Docket Item # 4 & 5
BAR CASE # 2013-00077 &
2013-00078

BAR Meeting April 17, 2013

ISSUE: Partial Demolition/Capsulation and Addition

LOCATION: 418 South Pitt Street

Figure 1: Comparison of an image from BAR2011-00105 & 00106 for 713 S Lee Street. Proposed addition incorporates the entire historic wall into the design.

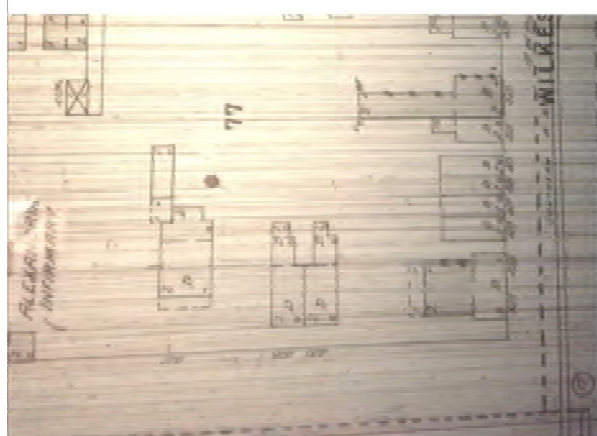
In the opinion of Staff, criteria 3 and criteria 5 to demolish and capsule generally are met and the Permit to Demolish should ~~not~~ be granted *for the portion now requested*. The Board regularly approves the *partial* demolition/capsulation of rear ells or additions to allow for a rear addition when they are not of particularly old or unusual construction. There are very few, if any, documented cases where the Board has approved the complete demolition of an historic rear ell. Demolition cases for 713 S. Lee Street (BAR2011-00105 & 00106) and 214 N. Alfred Street (BAR2012-00232) were approved for partial demolition of rear ells to allow for higher ceilings and additional floor area, but a significant portion of wall area was preserved and incorporated into the design.
